## Historic Site Preservation Board Staff Report

Case No: 5.1032 – HSPB # 3 – Welwood Murray Memorial Library

Application Type: Amendment - Certificate of Approval

**Attachment**  
**AMENDMENT TO**  
**HSPB CERTIFICATE OF APPROVAL**  
**Welwood Murray Memorial Library**

## Exhibit 1

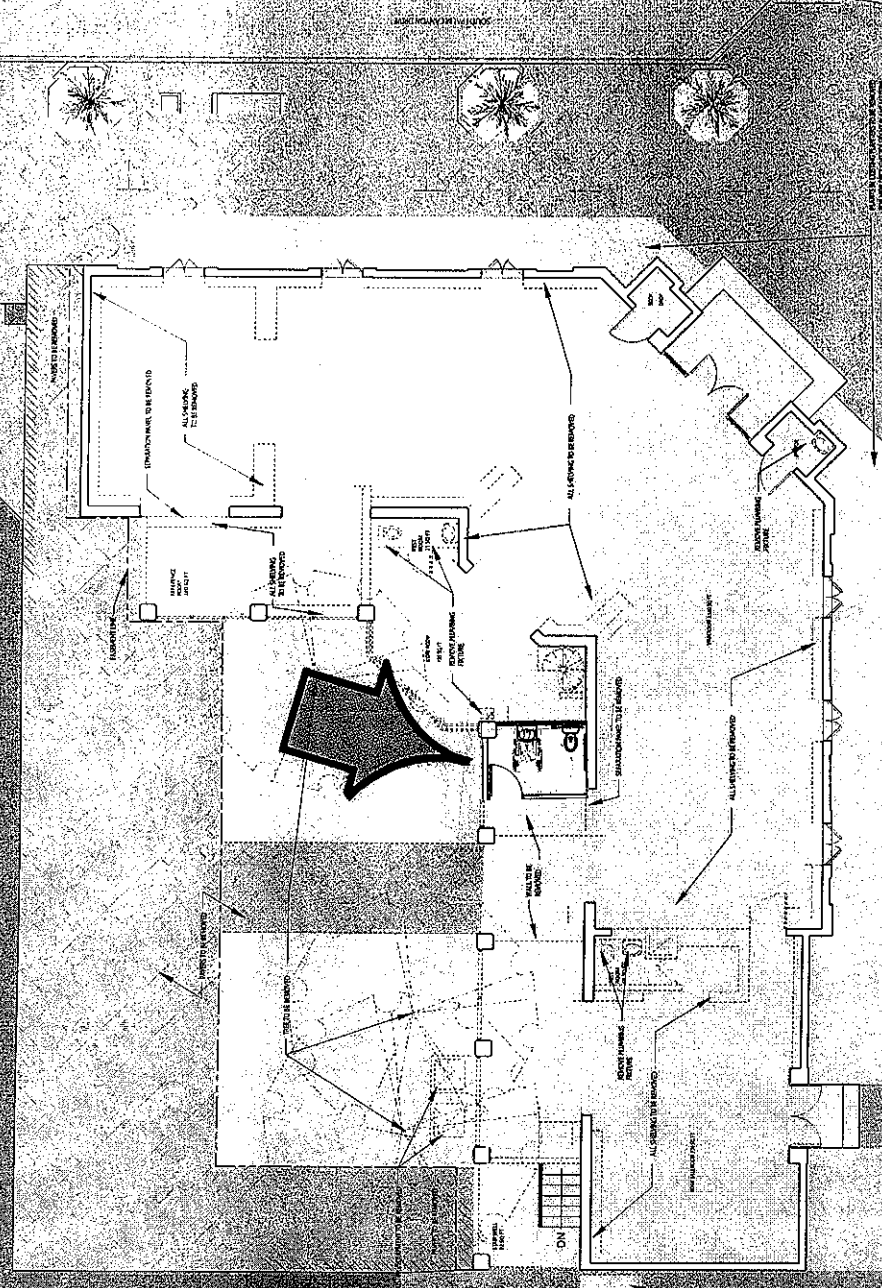
1. **Restroom:** It is proposed that rather than installing two ADA Accessible restrooms in the eastern most section of the rear enclosed patio rooms (See Exhibit 2 attached) that a single ADA Accessible uni-sex restroom be constructed entirely inside of the existing office area as noted on the attached sketch; see Exhibit 1. No exterior modifications will occur as a result of this requested change.
2. **Rear Door ADA Accessibility Modifications:** Currently there is a double door on the patio side of the Welwood Murray Memorial Library which has been used as the ADA access to the facility. It is proposed that minimal hardware changes be made to the door so as to increase the accessibility to the facility. (Note: This is subject to field review by Bldg Dept. after deadline for this application – an update will be provided on this item).

### PROPOSED LOCATION SINGLE UNI-SEX RESTROOM
